PRODUCT CHANGE NOTIFICATION

PCN-DC-HO3S-13

Business Unit	Product Line Code	Type of Change	Action	Date of issue
DC	AAB	Aesthetic	Notify Distributors and Field	3/26/2013

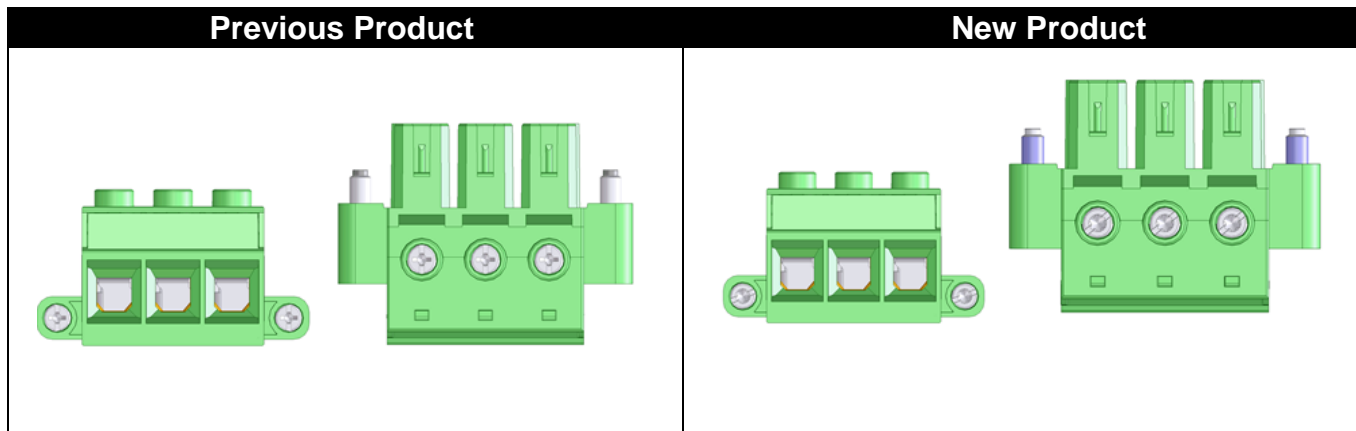
Due to our continuous product improvement process the PC 35 family will be changed regarding the screw for cable connection and the screw in the flanges from a plus/minus screw into a Torx-slotted screw T20. This allows the installer to apply the necessary torque. During the changing phase both screw variants might be delivered depending on the pole number. The revision-no. will be increased.
